Re; **Heritage Peaks Subdivision**

FEMA Flood Plain Report

Revised March 3, 2011

RESPONSE TO WILLIAMS ENGINEERING COMMENTS

FLOOD PLAIN STUDY
HERITAGE PEAKS SUBDIVISION

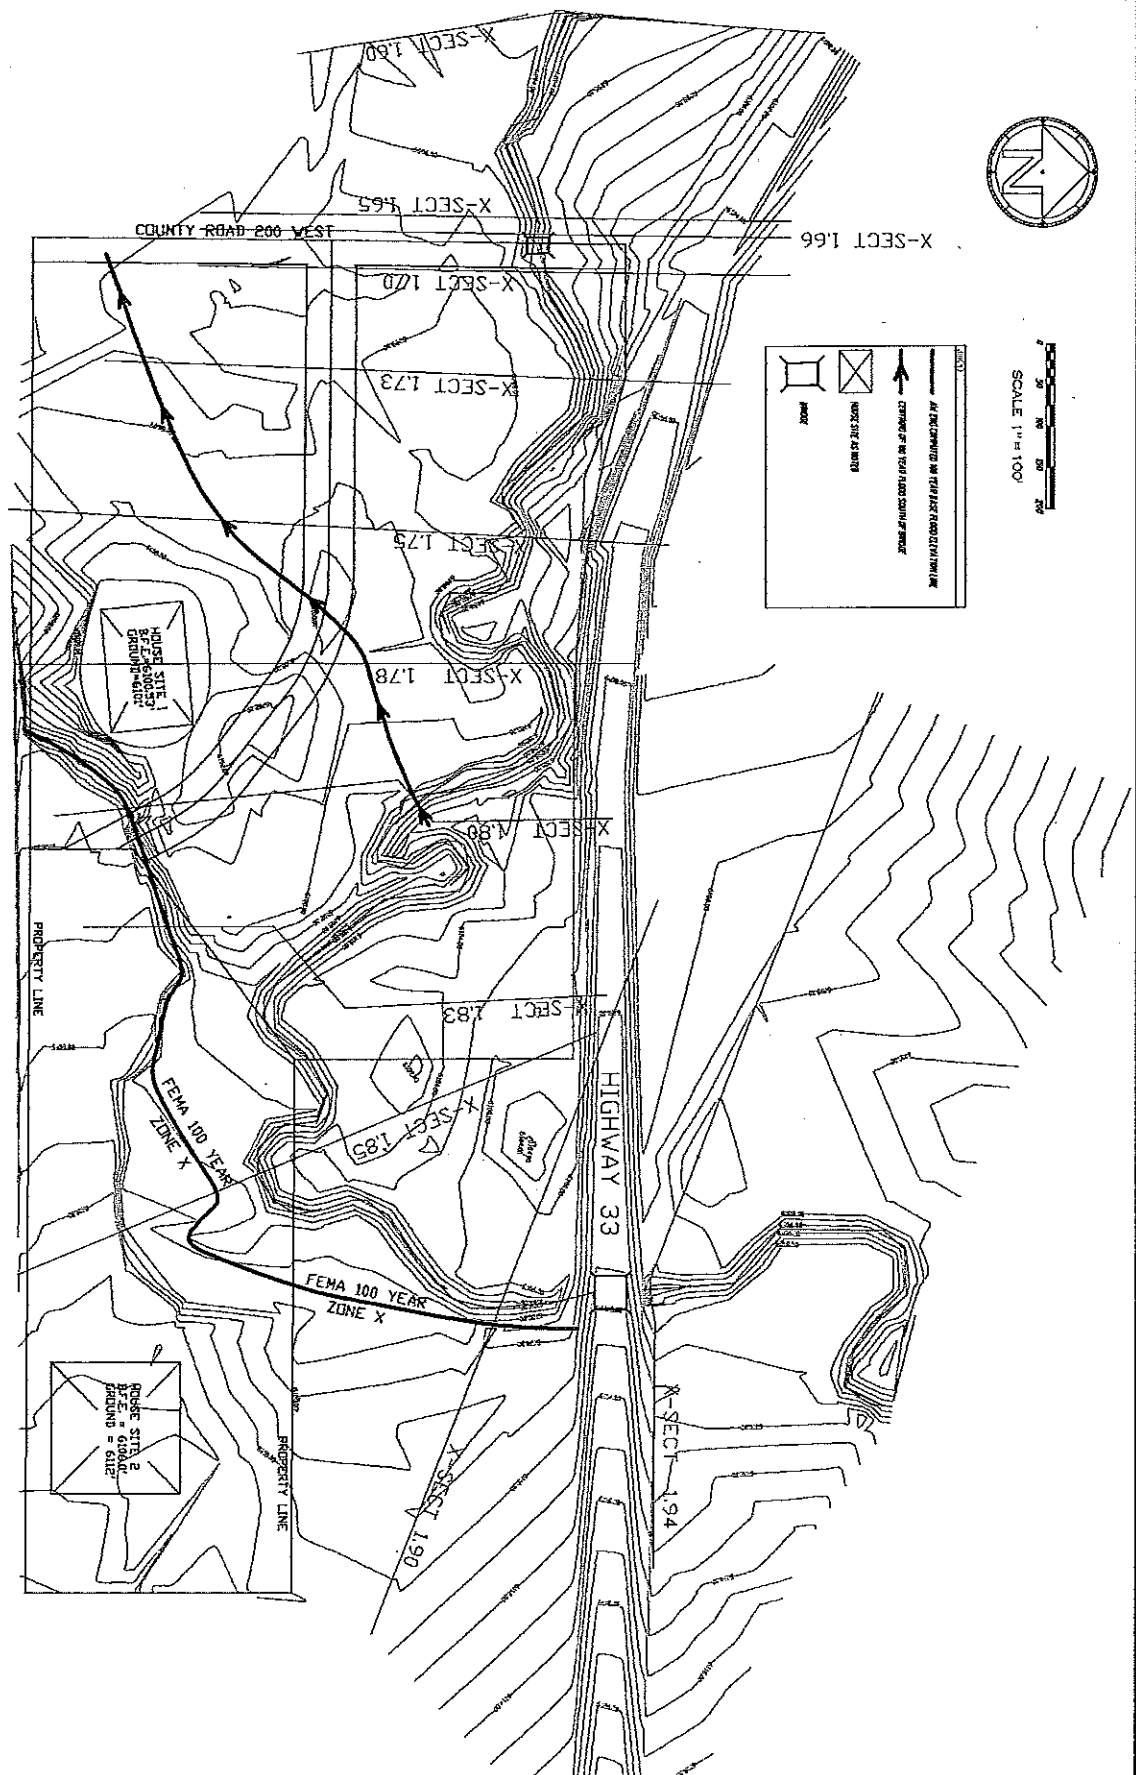
Item 4- The Flood Plain Map was reviewed and lines were checked to see that they agreed with the Hec Ras data.

Item 6- Cross Section Alignment - The cross Sections were reviewed and made as close to actual surveyed lines as possible. We had problems importing a base map or photo to have a good base map for the Hec Ras program, but the Map shown as A-1 is a surveyed and coordinated based map.

Item 13- The 6101 Contour line now appears on AW flood plain map, but in rerunning the Hec Ras with the road built up 1 foot from Cross Section 180 west, showed the BFE at Building Envelope 1 was 0.4 feet higher than previous model's shows.

Spring Cr- Road + 1 foot Plan: Plan Road + 1ft & Centroid South 3/4/2011

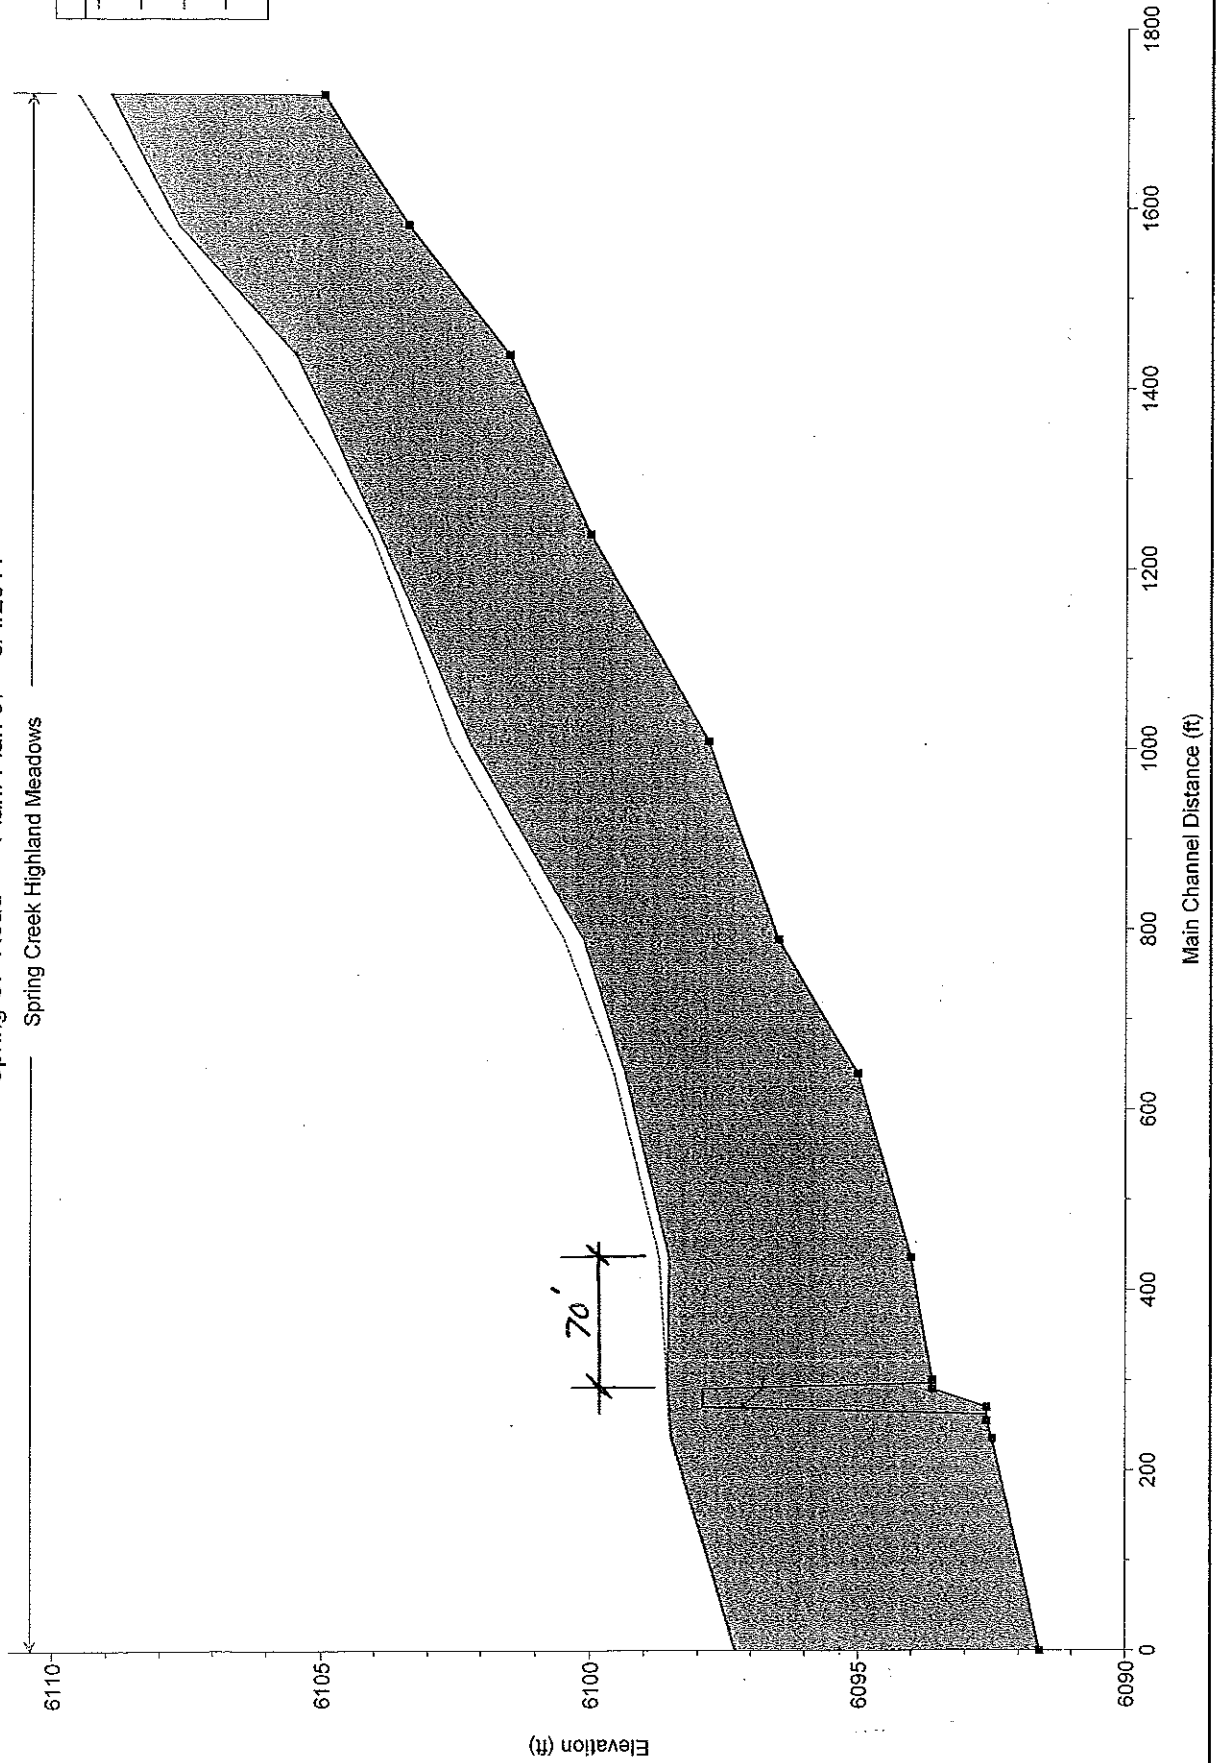
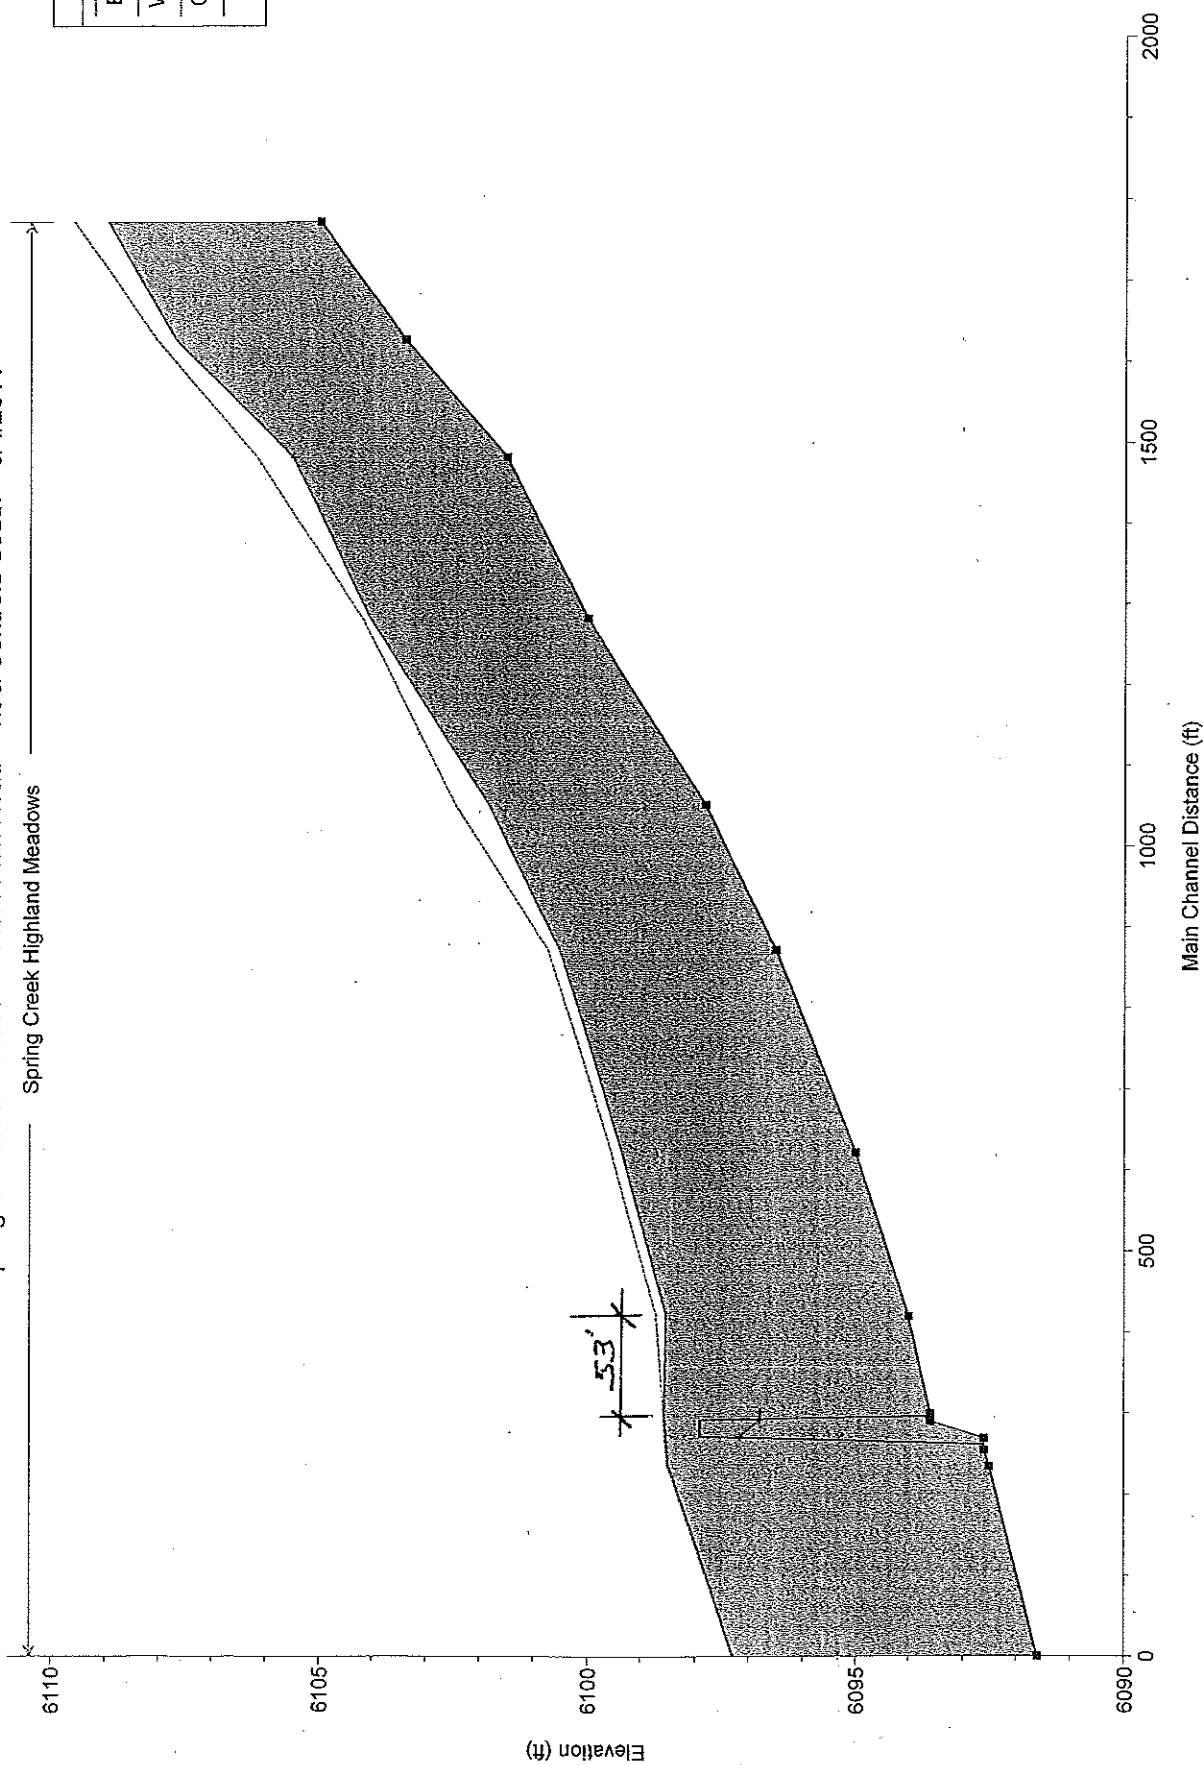
Item 14-Lateral Flow Component We have entered three scenerio's and run them to find the worst condition. The three are

- 1- Ground as is today with no road work.
- 2- # 1 with raising road grade 1 foot.
- 3- # + # 2 and shifting the flow of flood waters to the south to the centroid of the overflow area south of the bank.

The # 3 scenario is the worst condition for back water and for BFE at Building site 1. It was therefore used in running the final Hec- Ras making the FEMA flood plain map and preparing this report.

Spring Cr- Road Plan: Plan 07 3/4/2011
Bridge at 2000 West Co Road

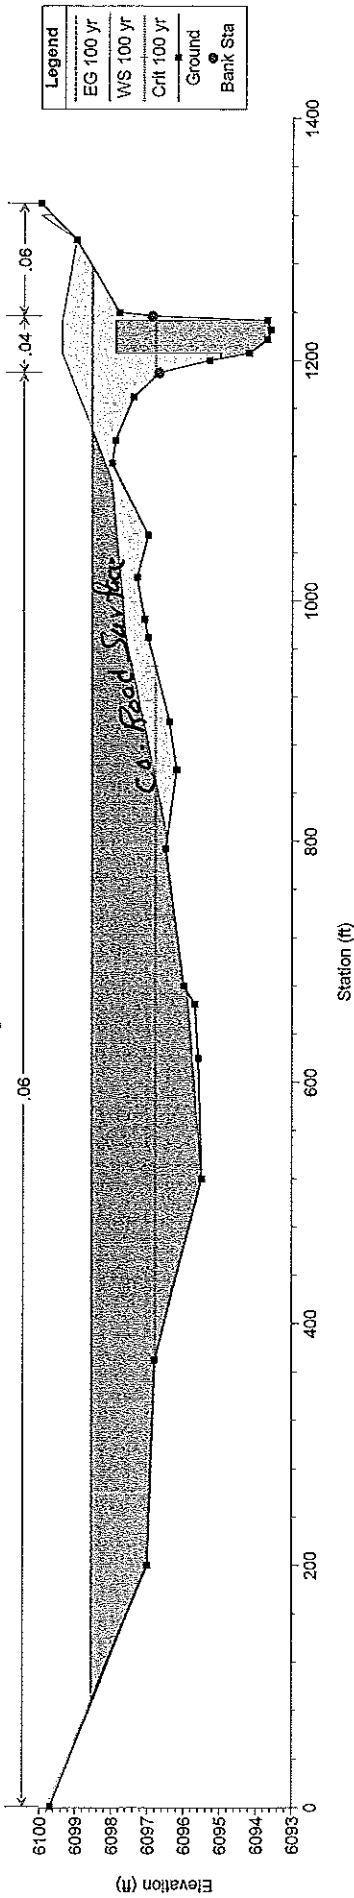
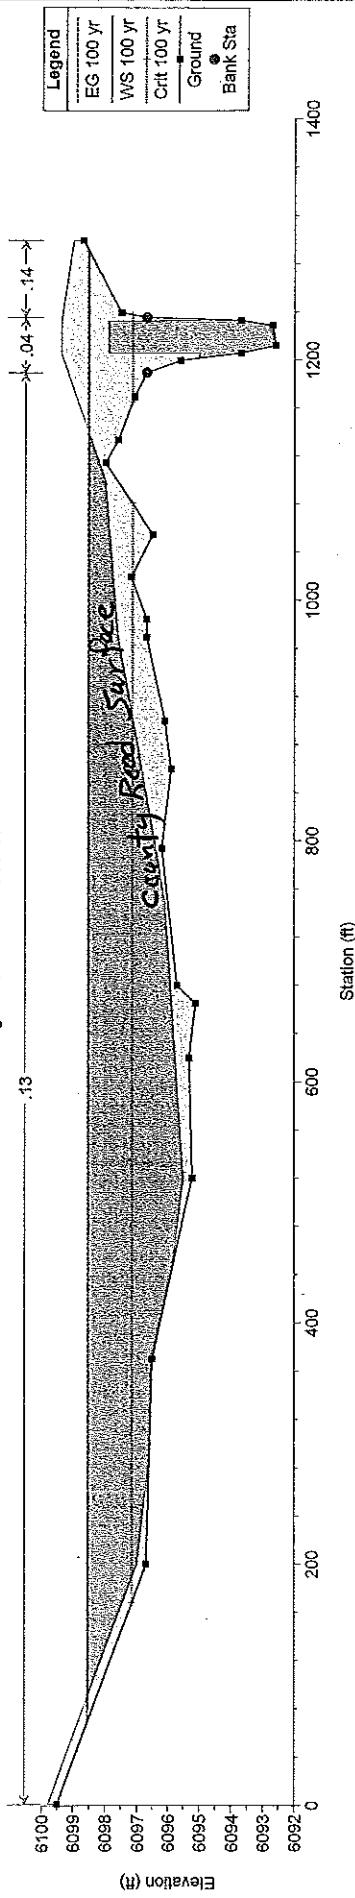
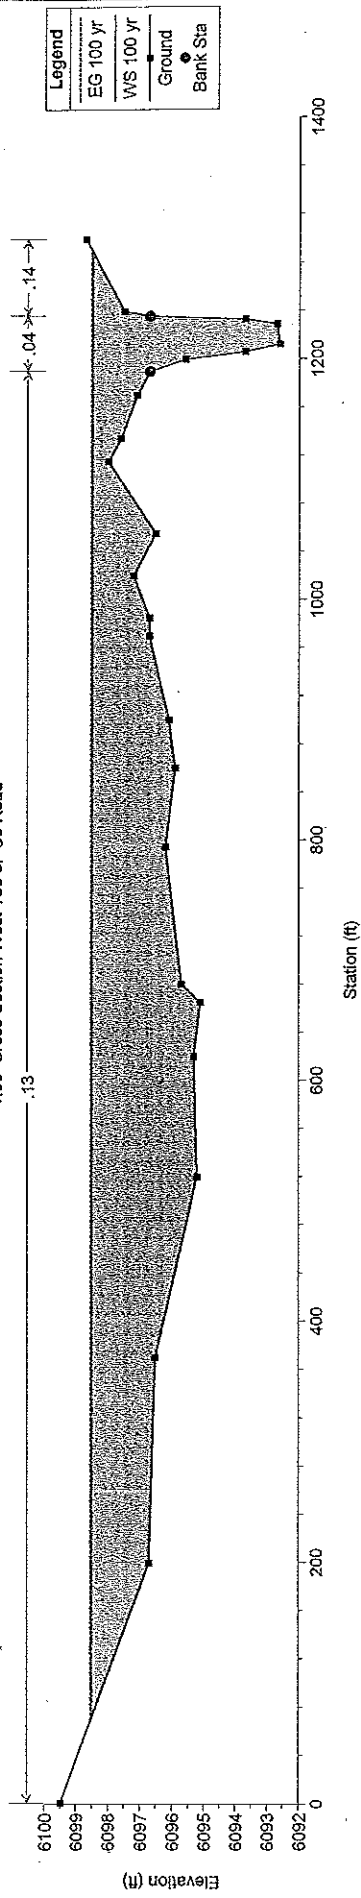
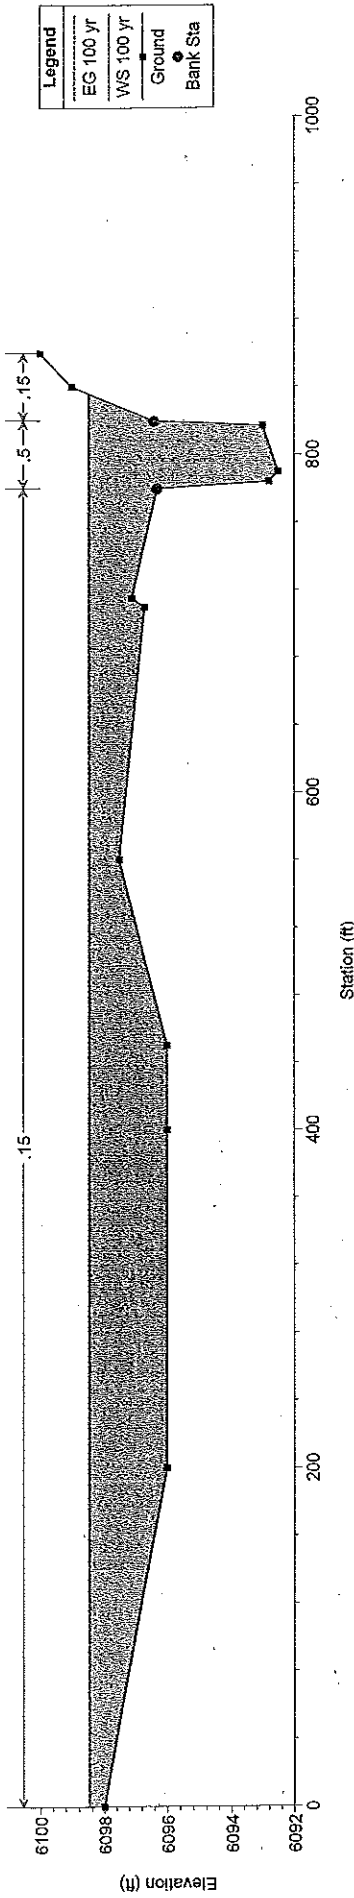
Item 2- After checking and correcting the data for the road toe and road profile cross sections, (1.70, 1.66 and 1.65 and the bridge sections) the program seemed to run OK.

Item 9- Backwater distance after checking all data at County Road 2000 West bridge now shows backwater at 70 feet using the worst scenario that was run. Three different scenarios (that follow)of private road cross sections was evaluated and are enclosed:

The worst case scenario (#3 above) was used in the report and mapping data. See Appendix D:1-2, & E:1
